**SUSQUEHANNA STEAM ELECTRIC STATION
PROPOSED LICENSE AMENDMENT NO. 285
FOR UNIT 1 OPERATING LICENSE NO. NPF-14
AND PROPOSED LICENSE AMENDMENT NO. 253
FOR UNIT 2 OPERATING LICENSE NO. NPF-22
EXTENDED POWER UPRATE APPLICATION
SUPPLEMENT TO REQUEST FOR ADDITIONAL
INFORMATION RESPONSES
PLA-6230**

**Docket Nos. 50-387
and 50-388**

The following provides the responses to NRC Questions 3, 4 and 8 contained in the Request for Additional Information Responses transmitted to NRC in References 2. The NRC Question and PPL Response for each is provided below.

**Figure 3.2 THERMEX
Methodology**

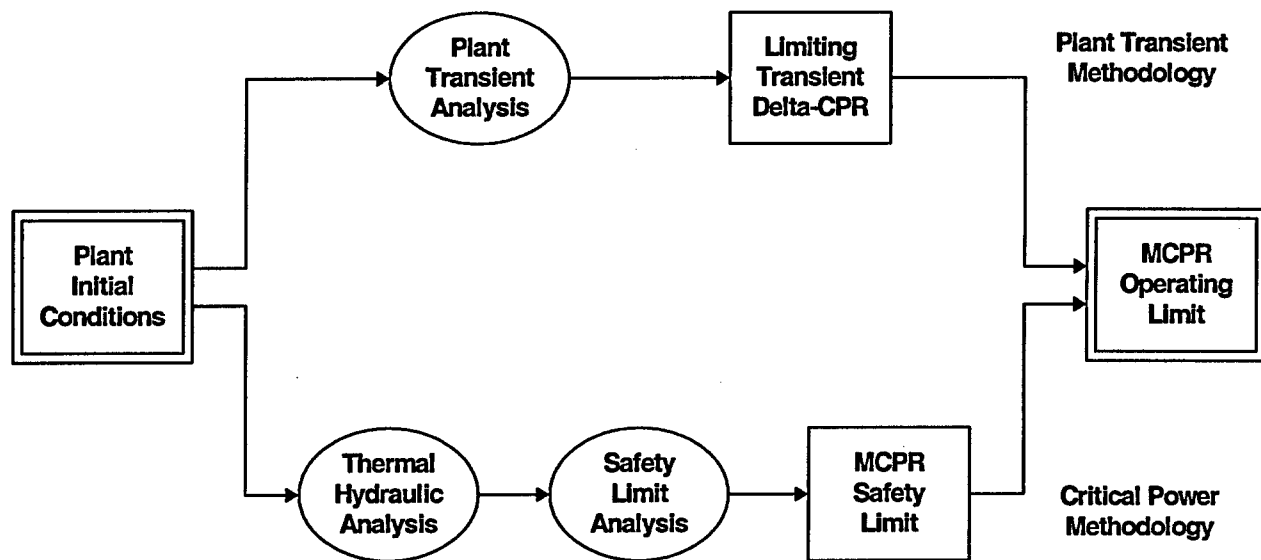
The AREVA thermal limits analysis methodology, THERMEX, is described in Reference A.3. The thermal limits methodology in THERMEX consists of a series of related analyses which establish an Operating Limit MCPR (OLMCPR). The OLMCPR is determined from two calculated values, the Safety Limit MCPR (SLMCPR) and the limiting transient analysis Δ CPR (Figure 3.2).

Figure 3.3 SLMCPR Methodology

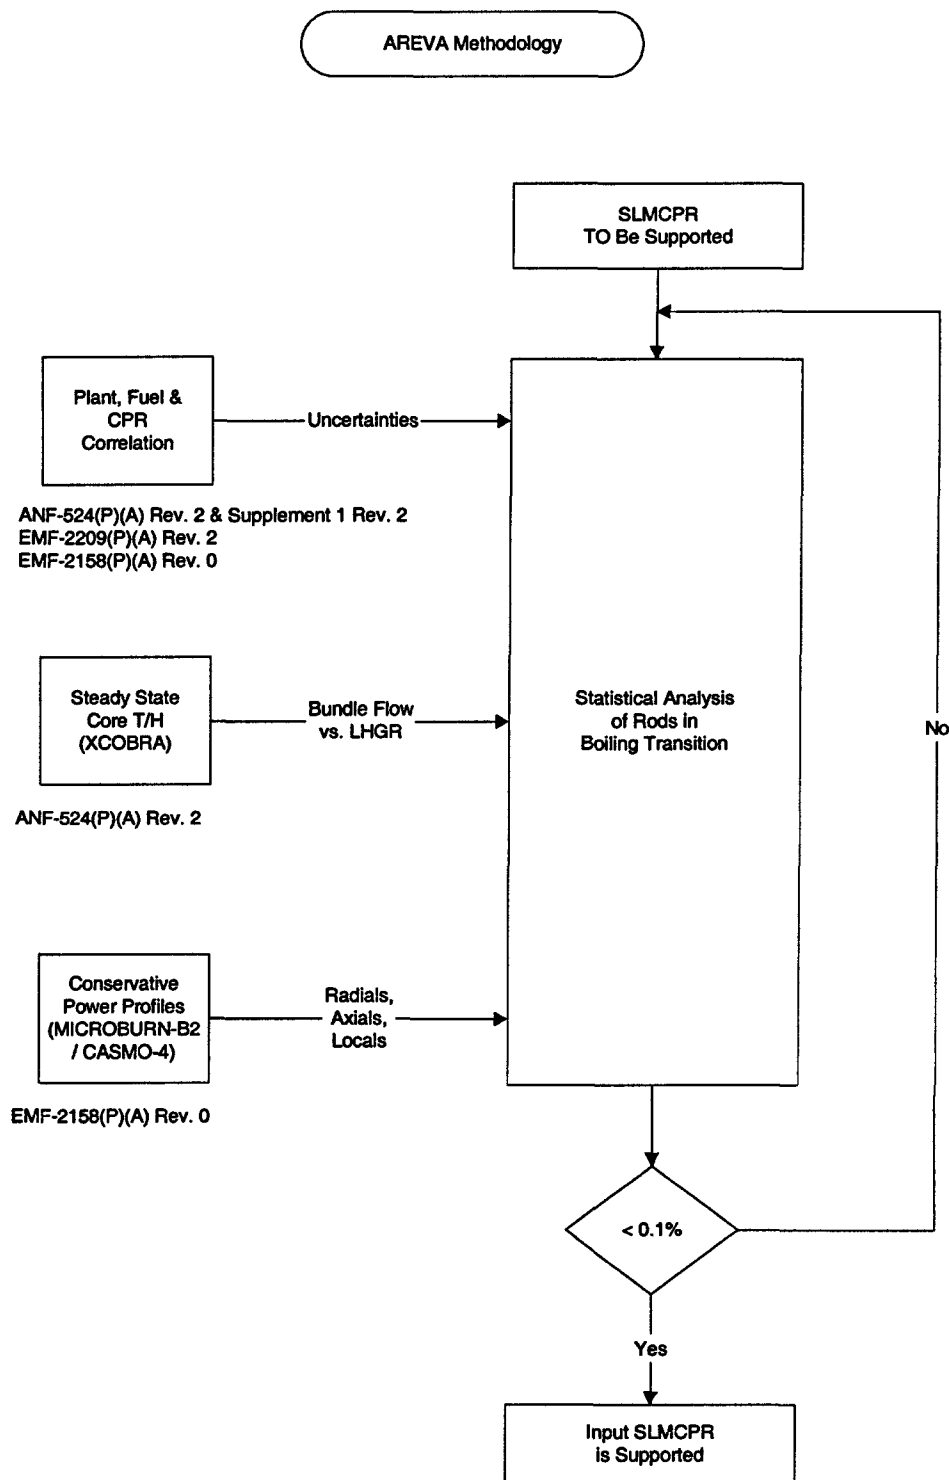
[] If the expected values of rods in boiling transition is less than 0.1%, the selected SLMCPR is supported (Figure 3.3).

Figure 3.4 SLMCPR Calculation Process

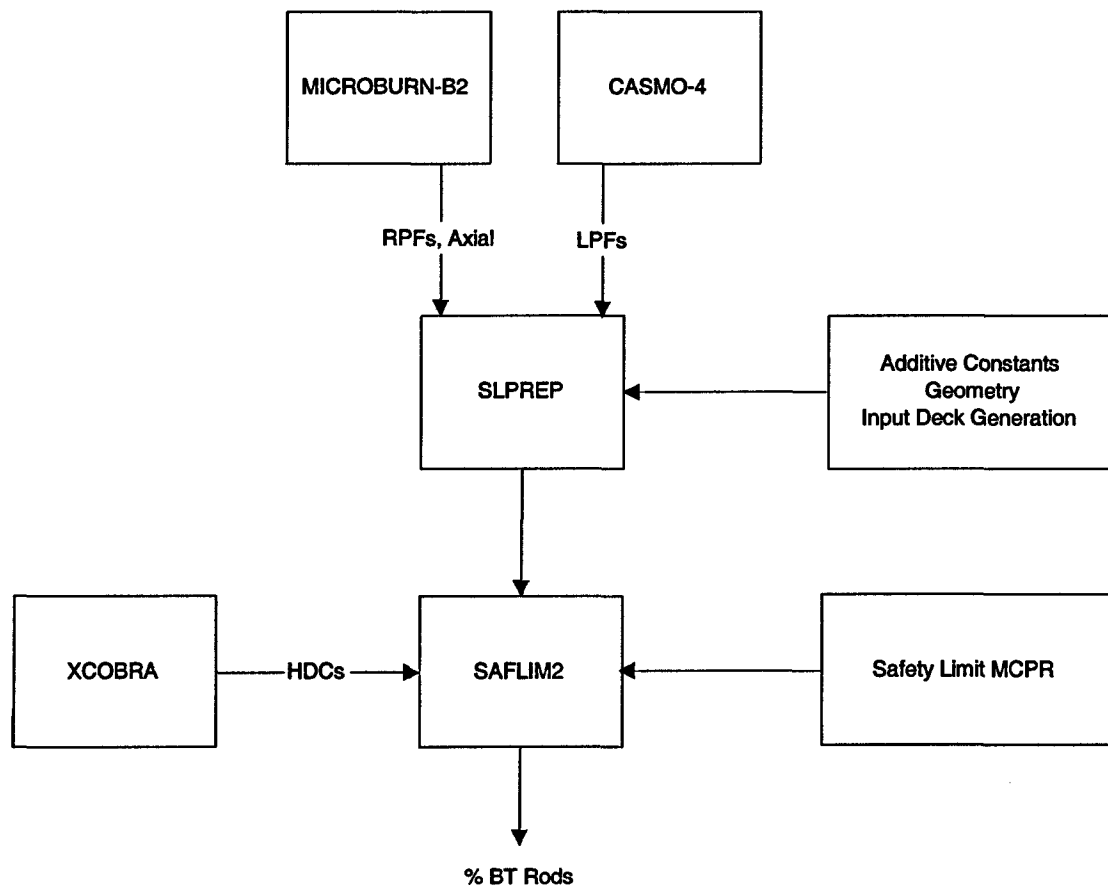
Figure 3.4 shows the computer codes and calculation process used in the SLMCPR analysis.

The SLPREP computer code shown in Figure 3.4 is an automation code used to collect data and prepare input for the SAFLIM2 code.

Figure 3.5 Transient Analysis Calculation Process

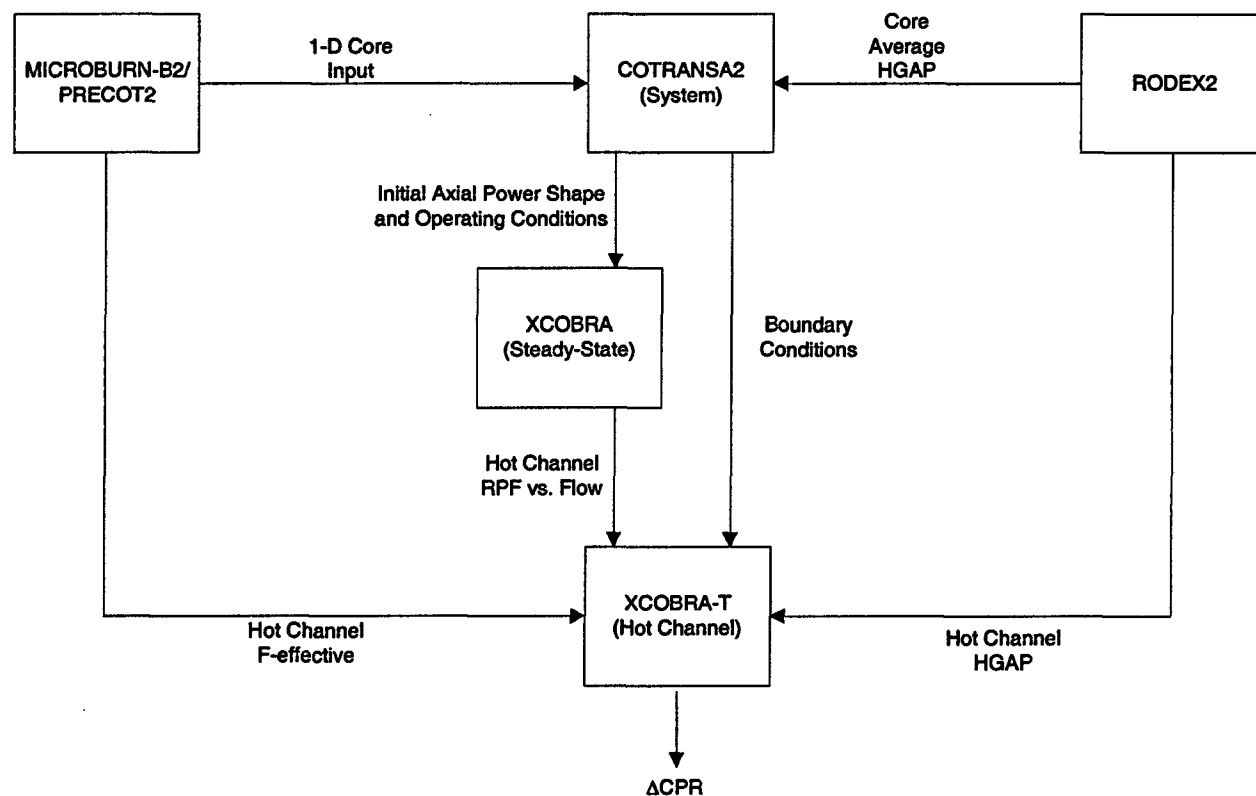
Figure 3.5 shows the computer codes and calculation process used in the evaluation of transient analyses.

Figure 3.6 LOCA-ECCS Calculation Process

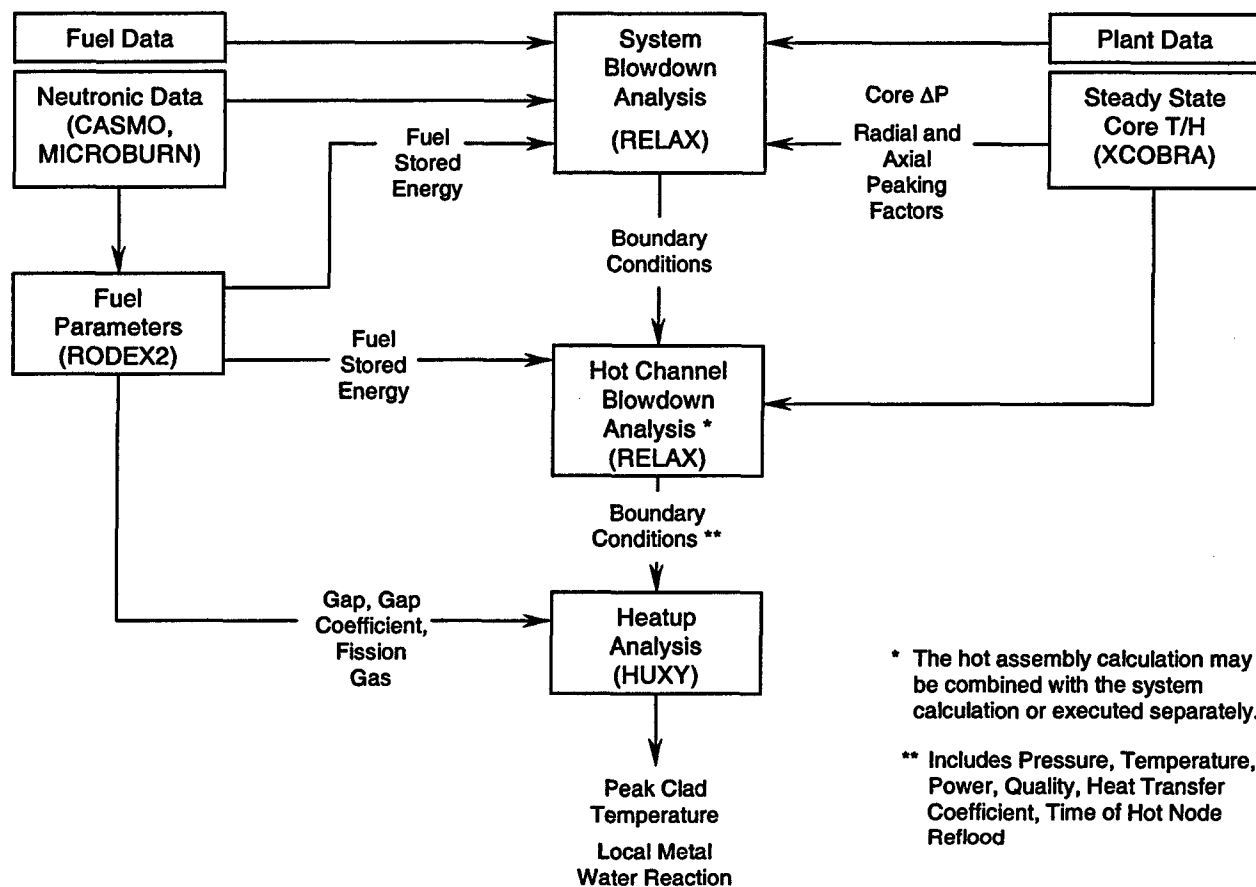
Figure 3.6 shows the computer codes and calculation process used in LOCA-ECCS analyses.

Figure 3.7 Stability Calculation Process

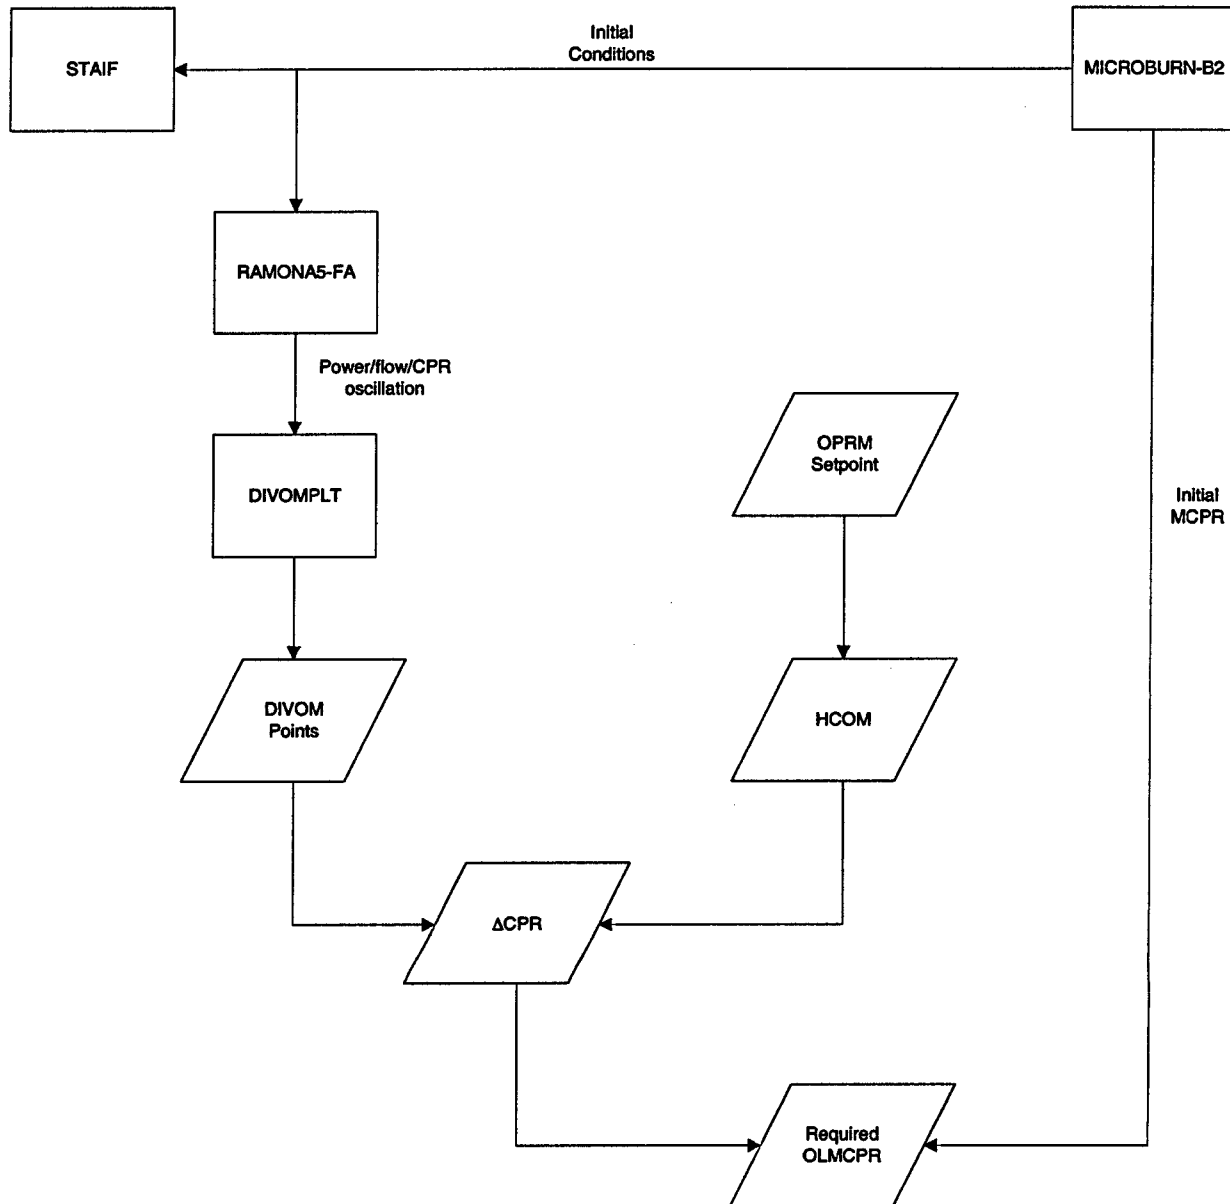
Figure 3.7 shows the computer codes and calculation process used in the OPRM setpoint analysis.

The DIVOMPLT computer code shown in Figure 3.7 is a post-processor used to calculate the DIVOM relationship from the transient power and CPR versus time information from RAMONA5-FA.

**Figure 4.1 Microscopic Thermal Cross Section of U-235
From Base Depletion and Branches**

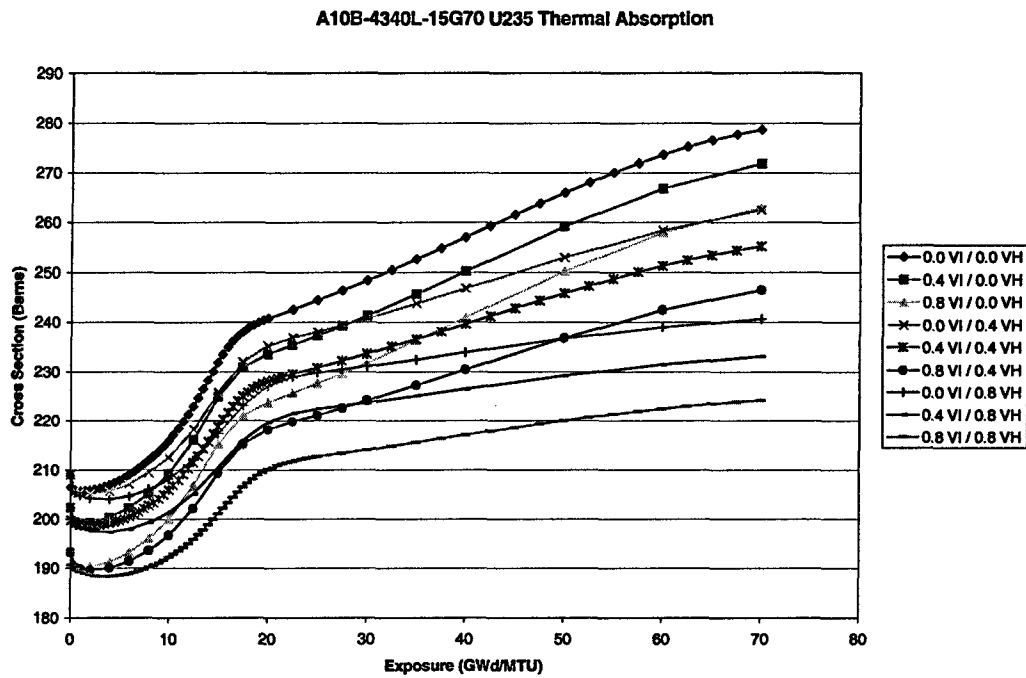
Functional representation of σ_x^i and $\Delta\Sigma_x^b$ comes from three void depletion calculations with CASMO-4. Instantaneous branch calculations at alternate conditions of void and control state are also performed. The result is a multi-dimensional table of microscopic and macroscopic cross sections that is shown in Figure 4.1 and Figure 4.2.

Figure 4.3 Microscopic Thermal Cross Section of U-235 at Beginning of Life

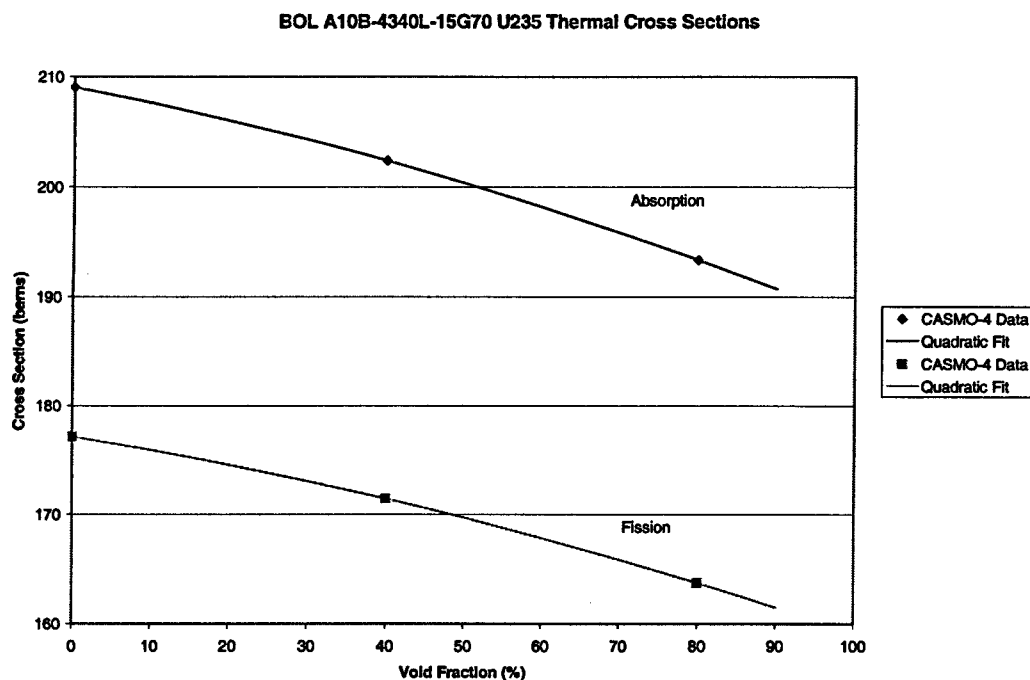
At BOL the relationship is fairly simple, the cross section is only a function of void fraction (water density) and the reason for the variation is the change in the spectrum due to the water density variations. At any exposure point, a quadratic fit of the three CASMO-4 data points is used to represent the continuous cross section over instantaneous variation of void or water density. This fit is shown in Figure 4.3 and Figure 4.4.

Figure 4.5 Microscopic Thermal Cross Section of U-235 Comparison of Quadratic Fit With Explicit Calculations at Various Void Fractions

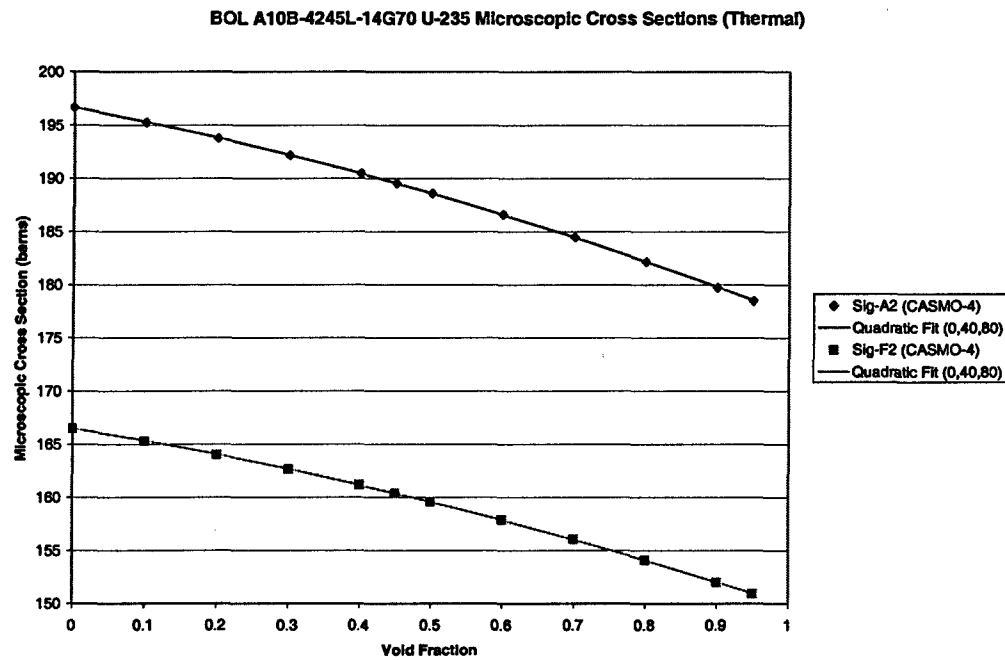
Detailed CASMO-4 calculations confirm that a quadratic fit accurately represents the cross sections as shown in Figure 4.5, Figure 4.6, and Figure 4.7.

**Figure 4.8 Microscopic Thermal Cross Section of
U-235 at 70 GWd/MTU**

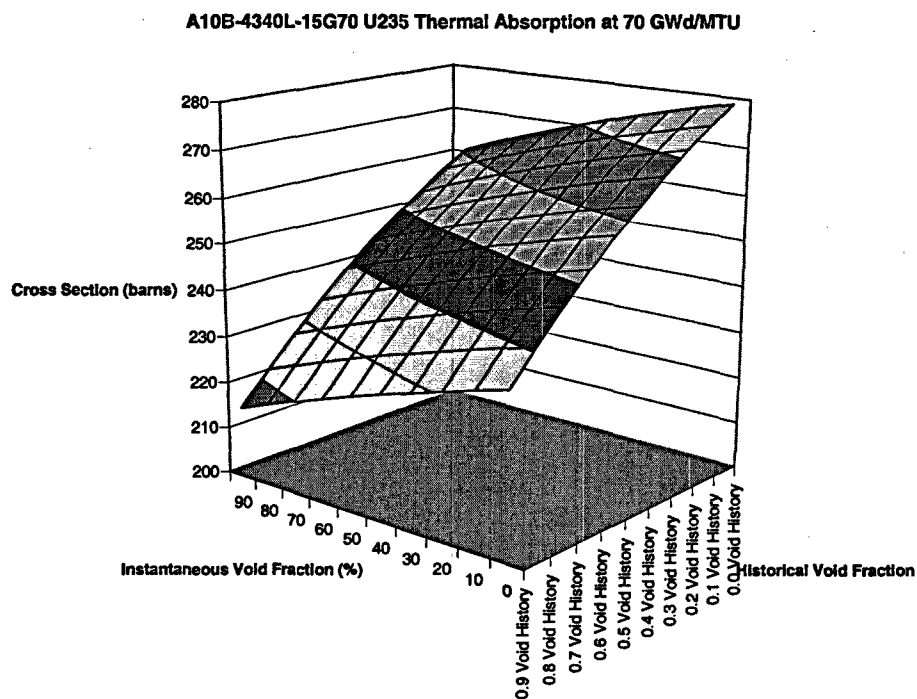
With depletion, the isotopic changes cause other spectral changes. Cross sections change due to the spectrum changes. Cross sections also change due to self-shielding as the concentrations change. These are accounted for by the void (spectral) history and exposure parameters. Exposure variations utilize a piecewise linear interpolation over tabulated values at [] exposure points. The four-dimensional representation can be reduced to three dimensions (see Figure 4.8) by looking at a single exposure.

Figure 4.9 Quadratic Interpolation Illustration of Microscopic Thermal Cross Section of U-235

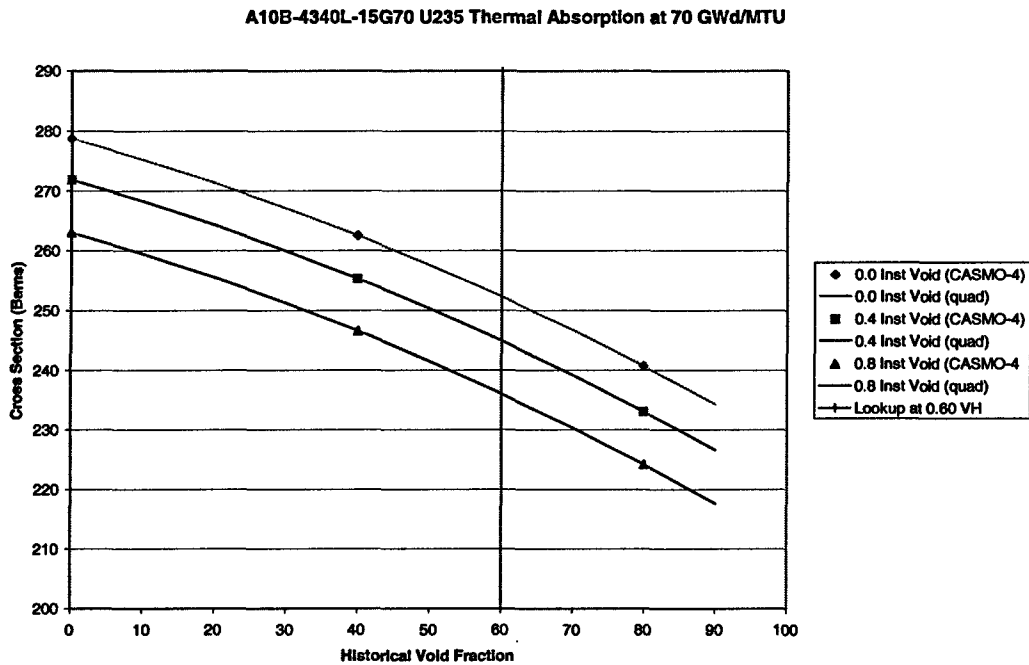
Quadratic interpolation is performed in each direction independently for the most accurate representation. Considering the case at 70 GWd/MTU with an instantaneous void fraction of 70% and a historical void fraction of 60% Figure 4.9 and Figure 4.10 illustrate the interpolation process. The table values
